Outer Dowsing Offshore Wind

Response to Section 51 Advice

Schedule of Changes for Plans

Document Reference: 2.0

Drawing No: 22000087_PLN_INFO_13230.8

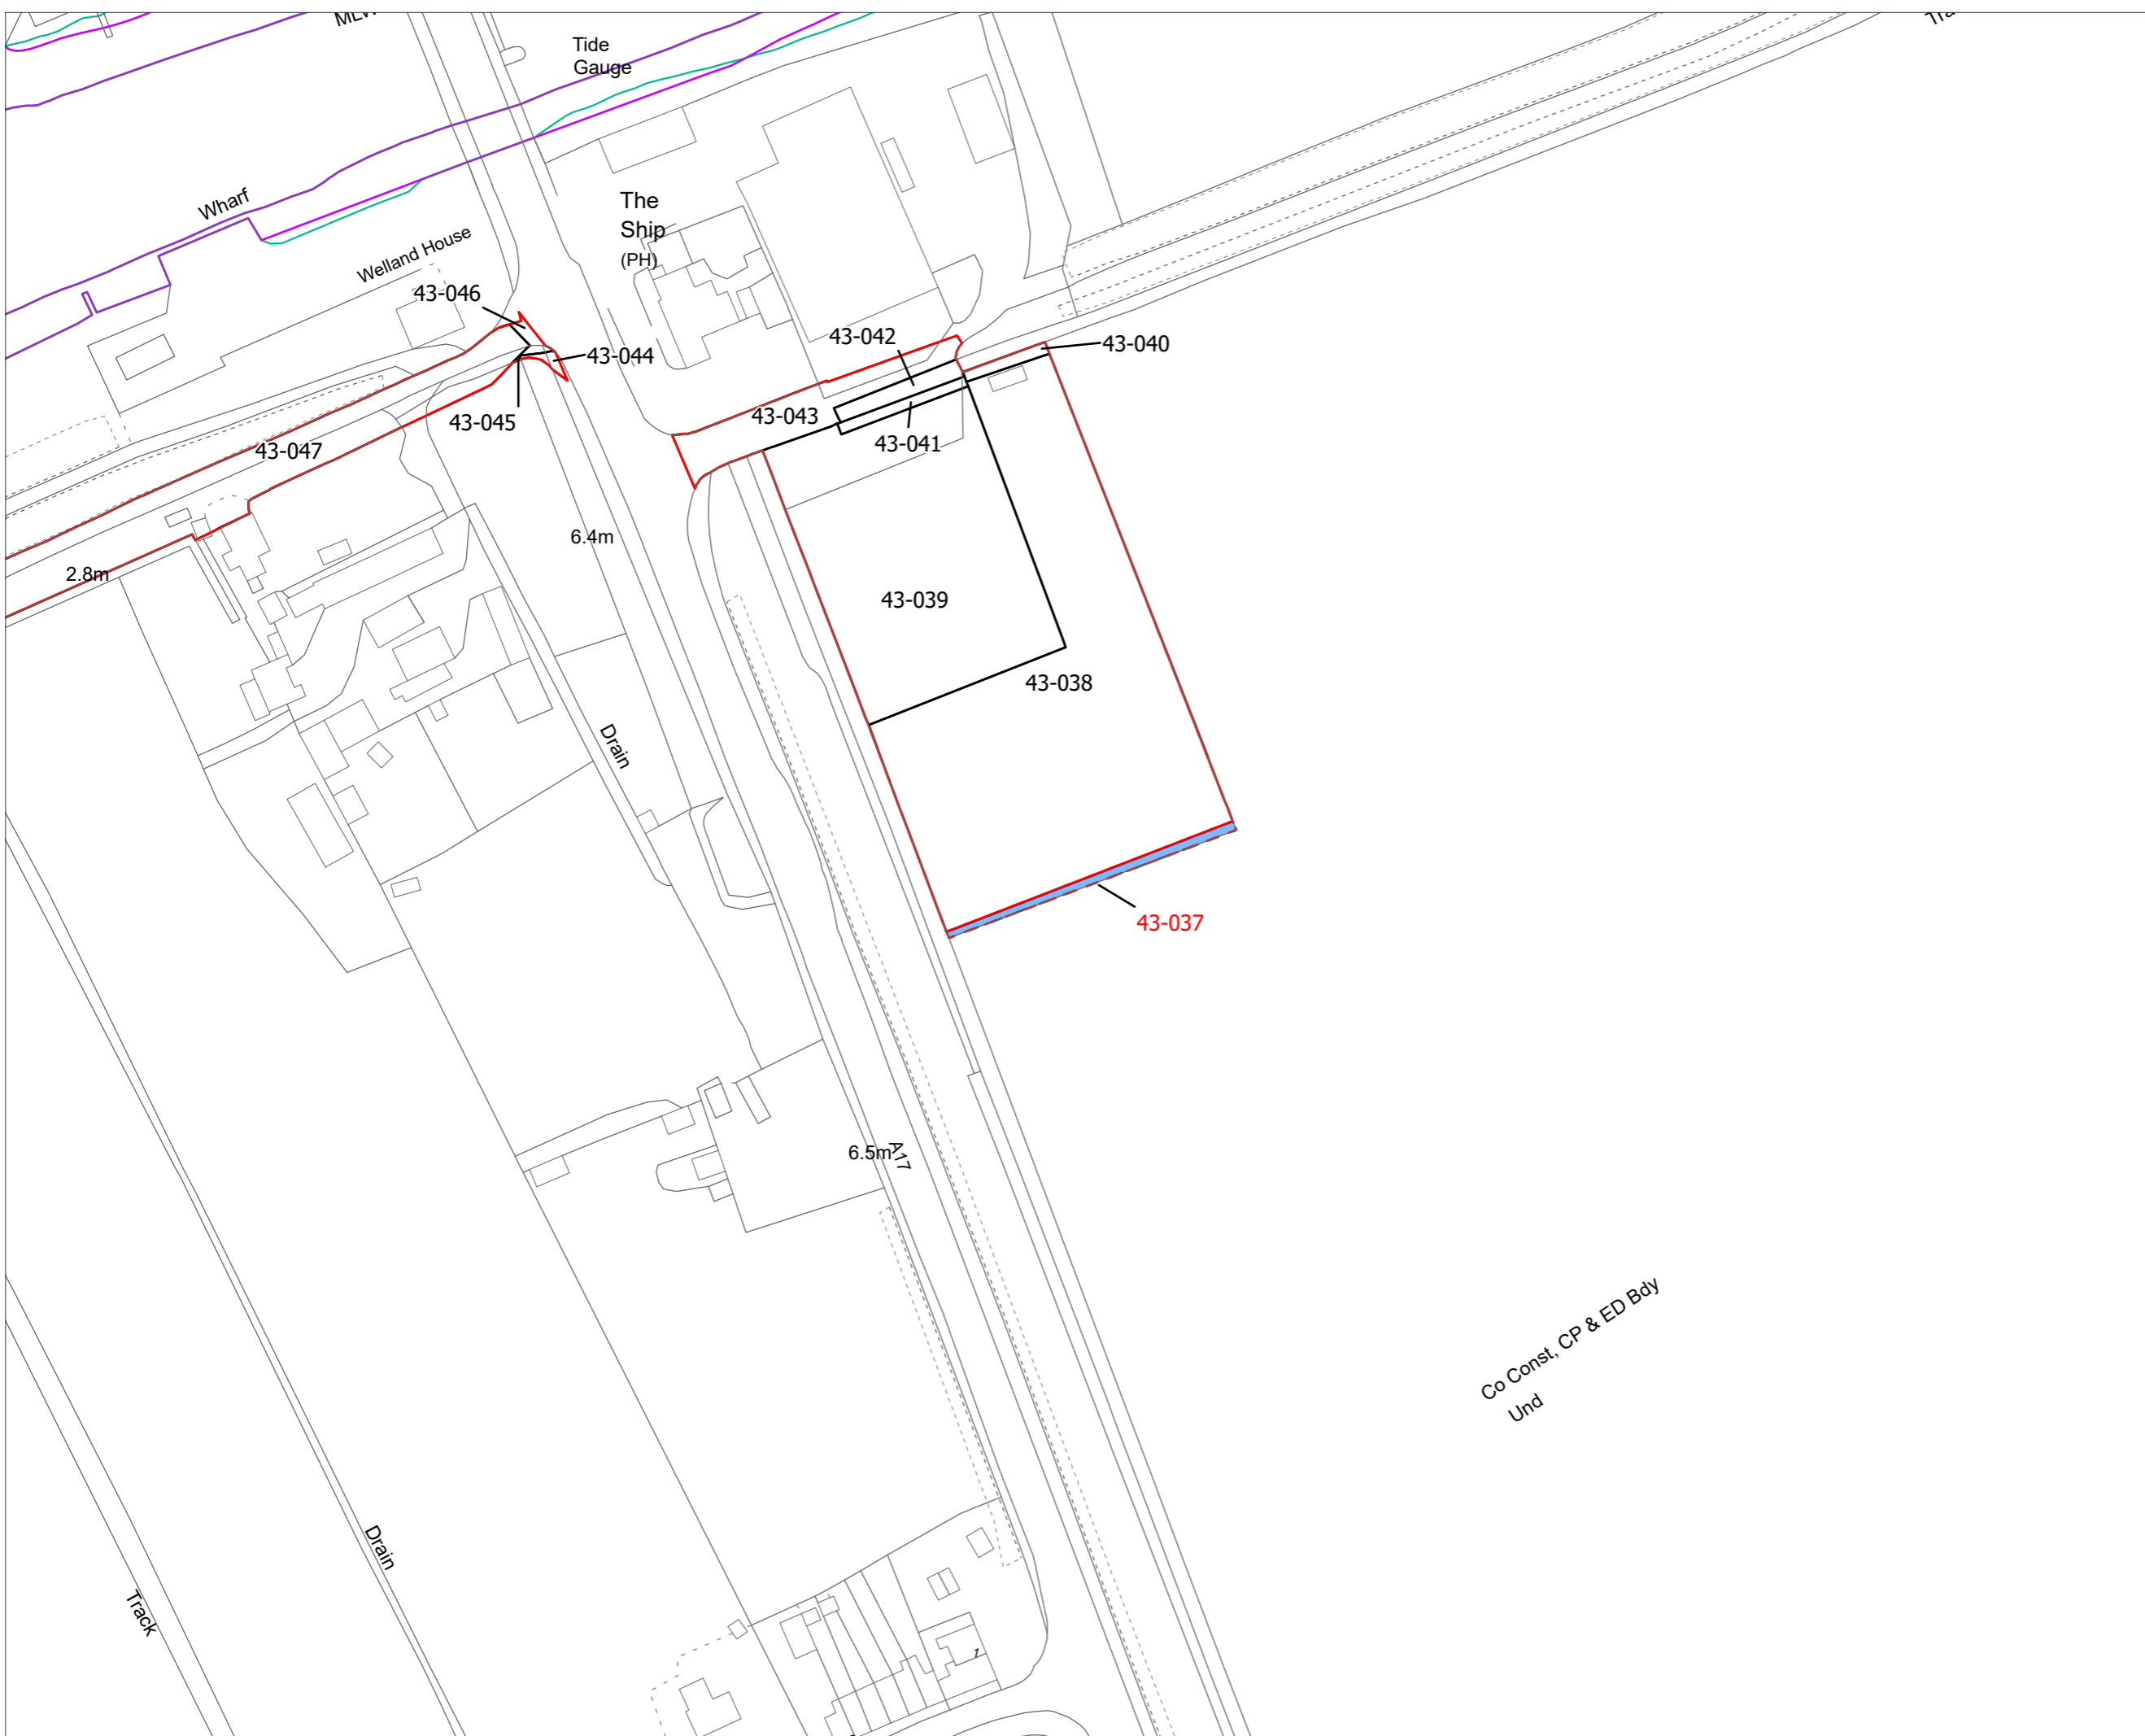
| Plan Numbers | Reference | Plot Number(s) if appropriate | Date of Change | Revision Change | Change Made | Reasons for Change |
|--------------|-----------|-------------------------------|----------------|-----------------|---|---|
| 2.5 | | 40-004 | July 2024 | V2 | Plot removed. | Plot removed from Order Limits, to exclude land within residential boundary. |
| 2.5 | | 40-005 | July 2024 | V2 | Plot removed. | Plot removed from Order Limits, to exclude land within residential boundary. |

Drawing No: 22000087_PLN_INFO_13230.9

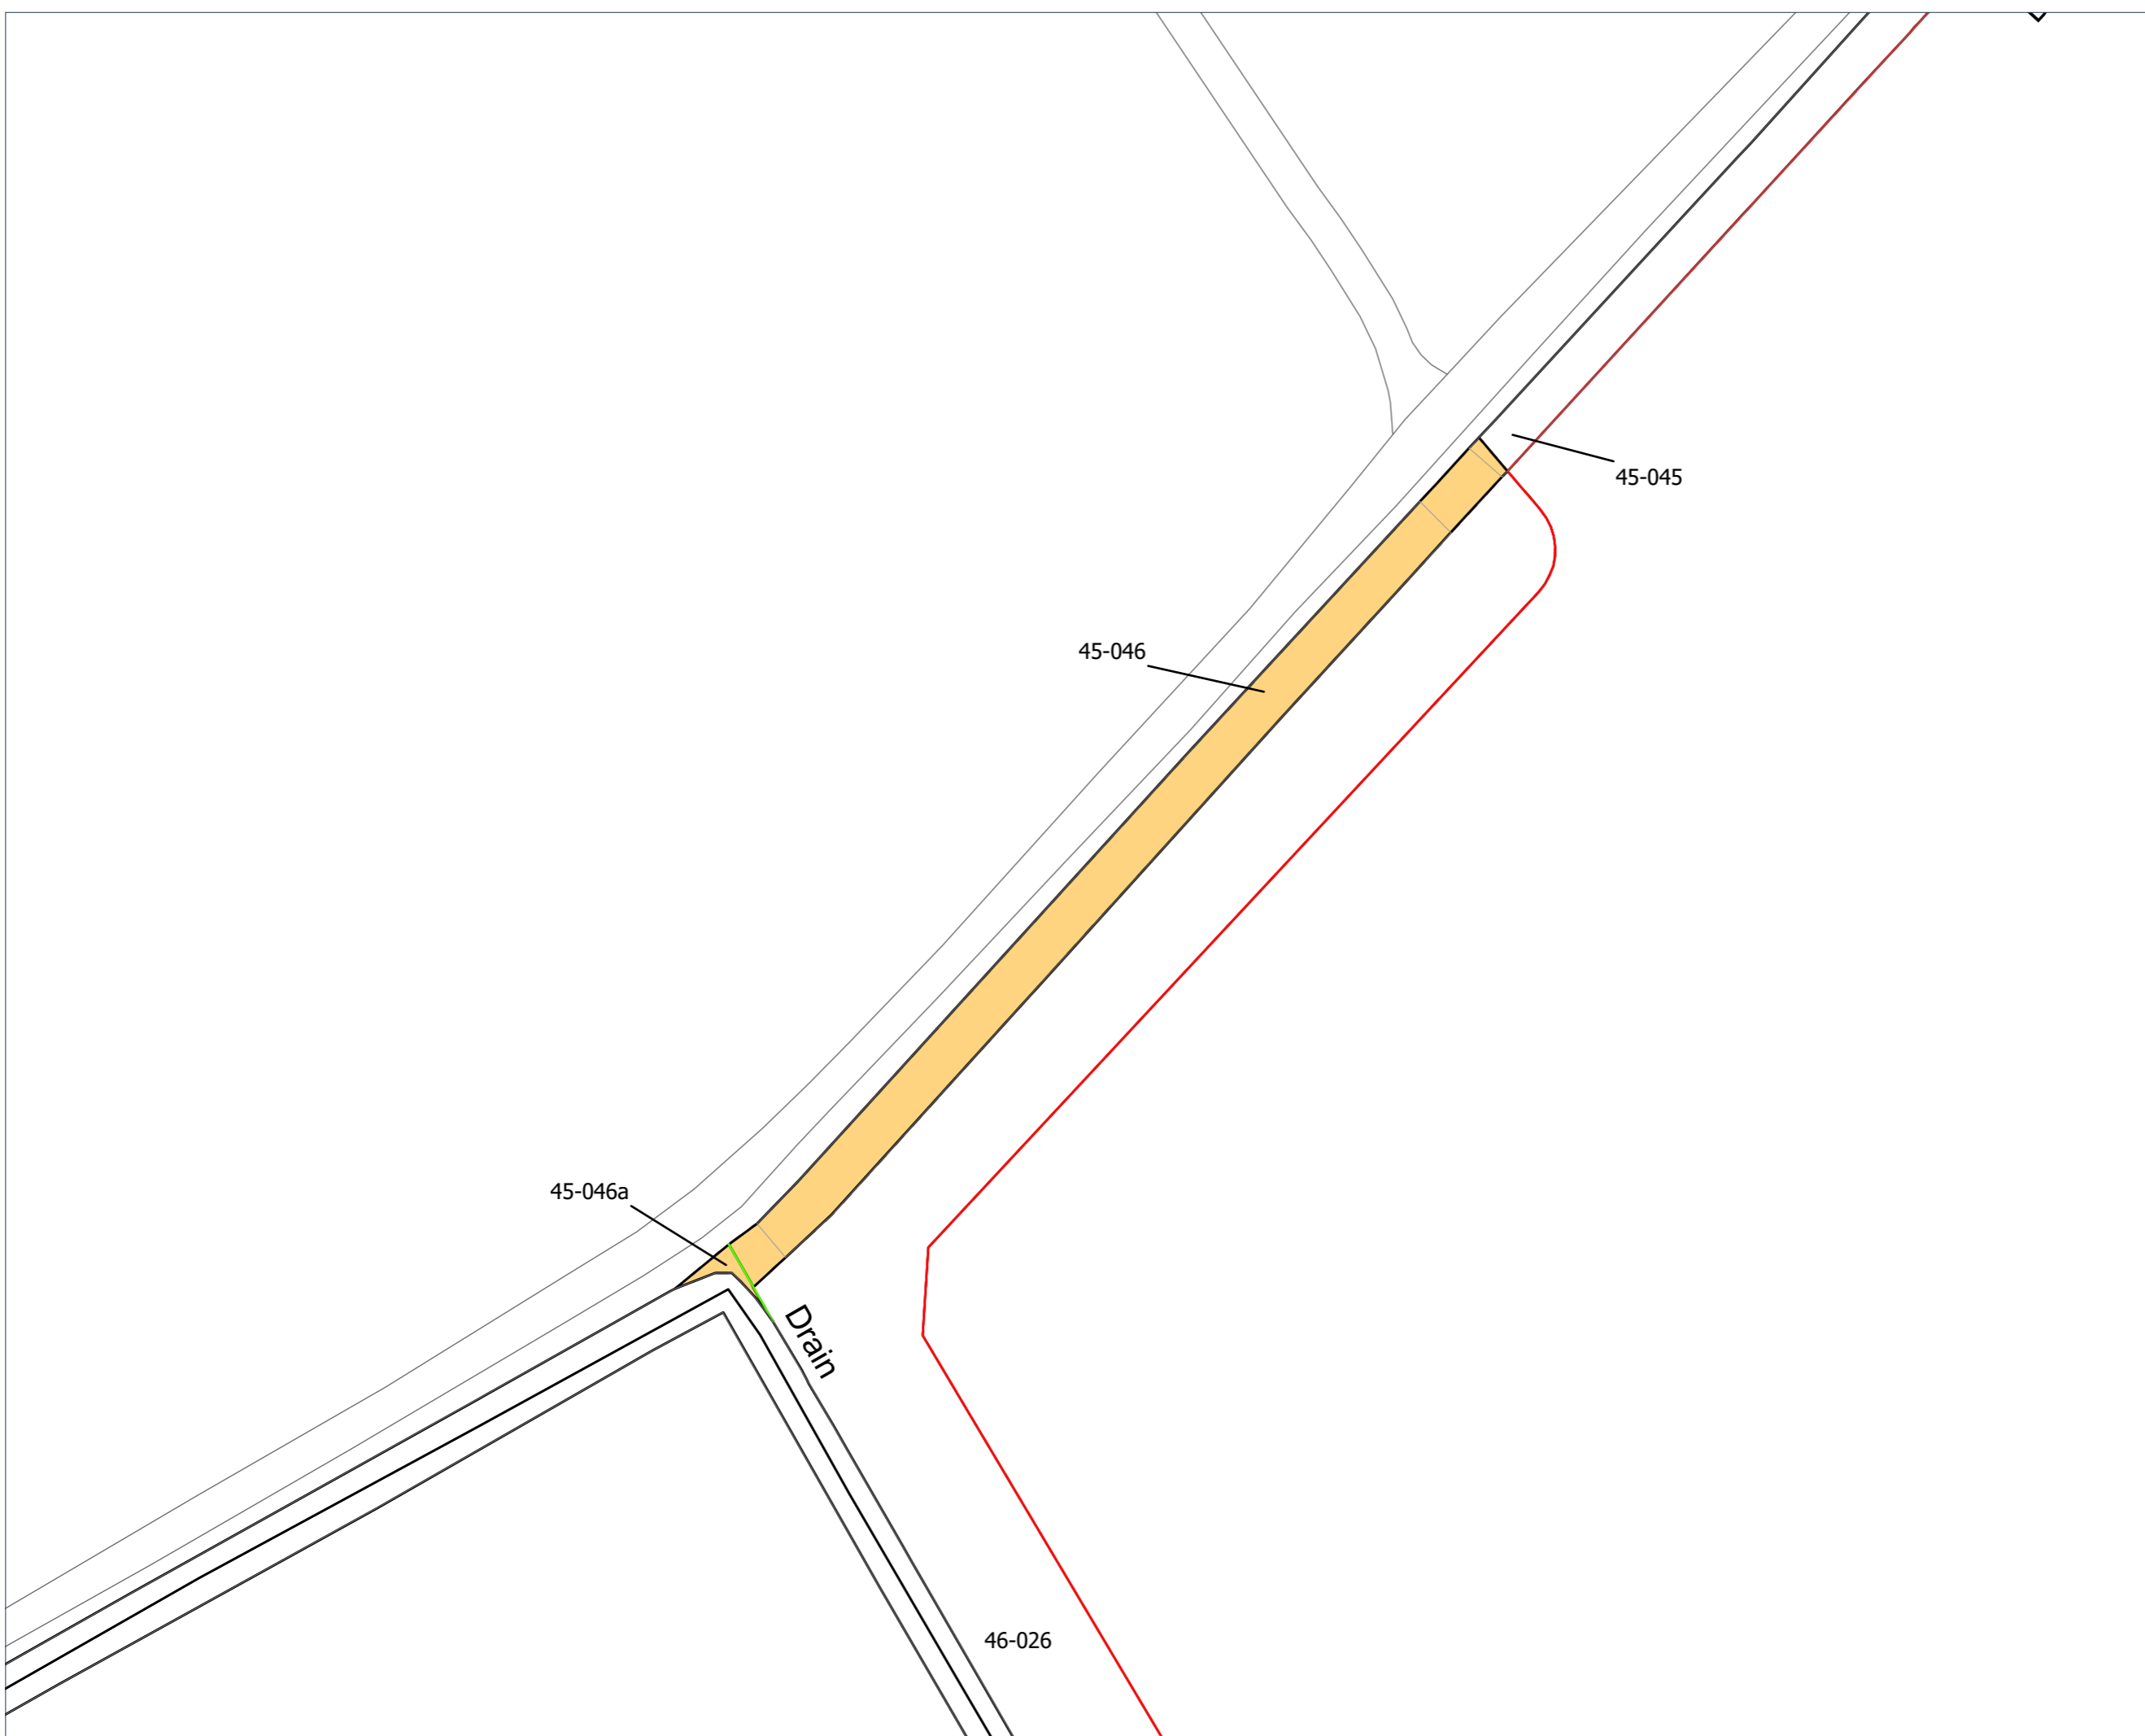
| Plan Reference Numbers | Plot Number(s) if appropriate | Date of Change | Revision Change | Change Made | Reasons for Change |
|------------------------|-------------------------------|----------------|-----------------|---|---|
| 2.5 | 45-046a | July 2024 | V2 | Label added to annotate new plot 45-046a. | Update to capture plot 45-046 split as different rights are required over these areas. |
